TE Connectivity

Product Change Notification: PCN-24-201711

Product Description: (Text limited to 120 characters)
HPC-200 & HPC-250 For ESS.

Change the insulation material.

HPC-200 Plug Original

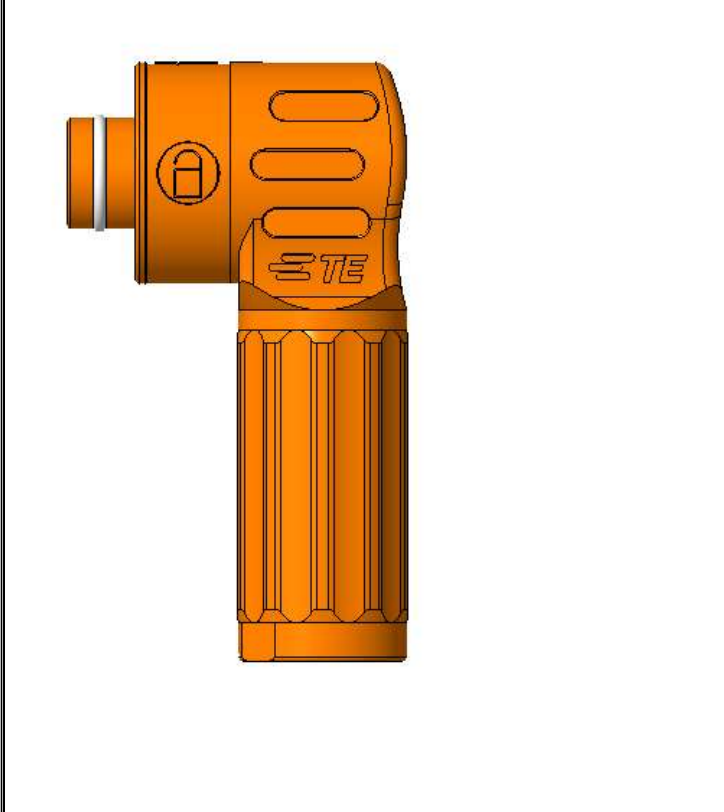
1. Insulation material PA66-GF30, Carbon emission 6.6

1. Insulation material PA66-GF30, Carbon emission 3.8

Add marks on the surface of HPC-200 plug.

HPC-250 Plug Original

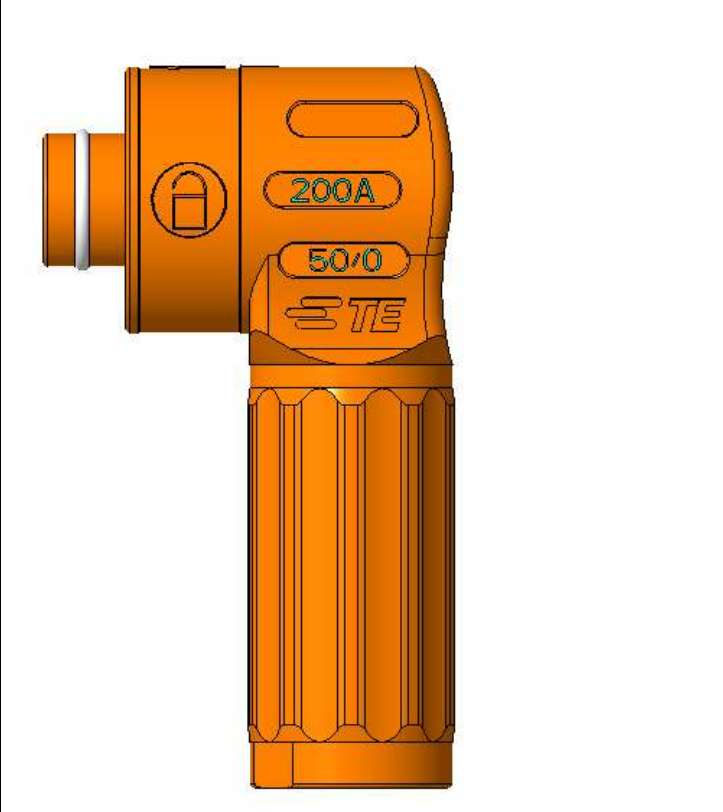
Add marks on the surface of HPC-250 plug

HPC-200 grommet original

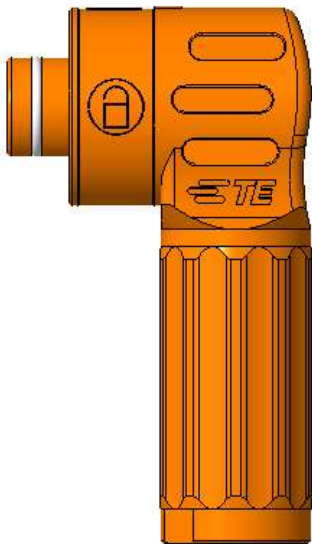
Add marks on the surface of grommet of HPC-200.

HPC-250 grommet original

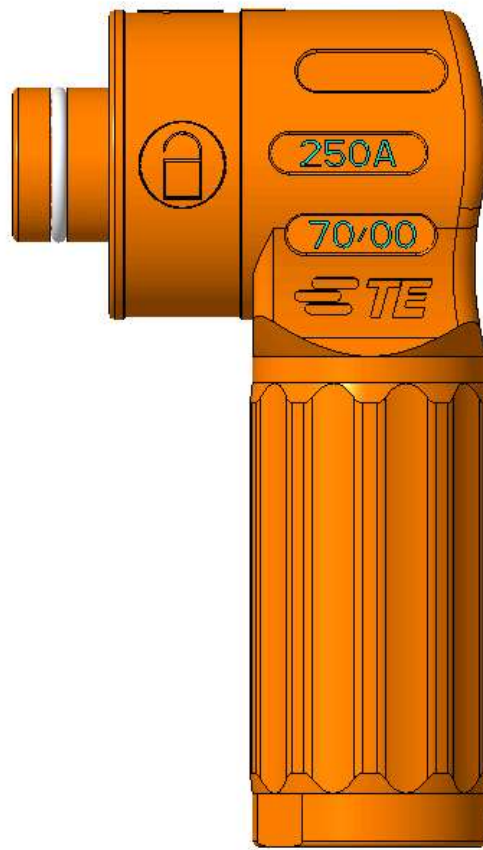
Add marks on the surface of grommet of HPC-250.
